# General Correspondence

From: Lowe, Leonard, EMNRD [mailto:Leonard.Lowe@state.nm.us]
Sent: Wednesday, January 12, 2011 11:05 AM
To: Pablo, Alberta
Subject: Integrity Testing Report for GW-401, Exterran HSE Farmington

> Re: Discharge Plan Submittal Request (Designated GW-401) Integrity Testing report. Exterran, 1280 Troy King Road, Farmington, N.M. 87401 Section 12, Township 29 North, Range 14 West NMPM

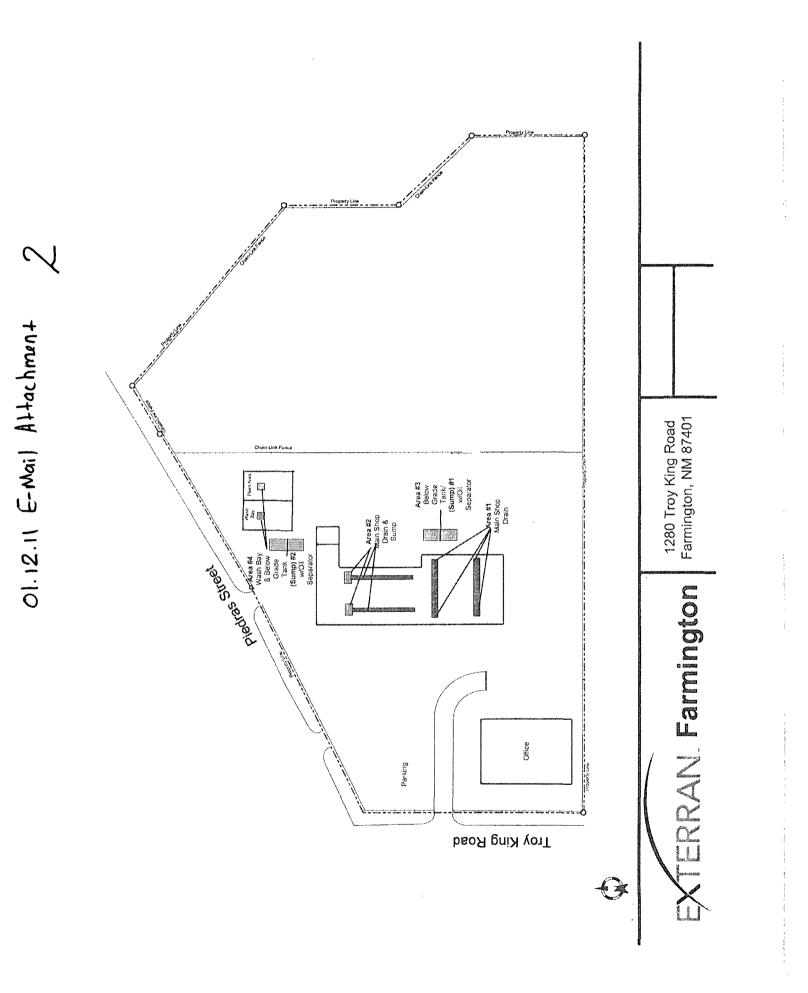
- Exterran's submittal identified the areas for testing: Area #1 (Main shop), Area #2 (Main Shop), Area #3 (Exterior Sump Drain Discharge line) and Area # 4 (Wash bay 1 & 2 and Sump # 3). OCD cannot identify any of these locations on the submitted attached drawing for the Exterran facility. OCD does not want to assume these areas, please submit another drawing or give information on which lines were identified within the drawing.
   *See attached revised facility map.*
- 2. Please annotate the operating pressure for these lines tested, or note if they operate under atmospheric pressure.
  - 2. Atmospheric testing
- OCD does not understand pressure testing of a sump to 3 lbs/sqr inch., explain.
   The drain lines we're pressure tested and sump in the shops and below grade tanks were hydrostatic/ atmospheric tested.

### I have made comments below and a revised facility map is attached. Thank You.
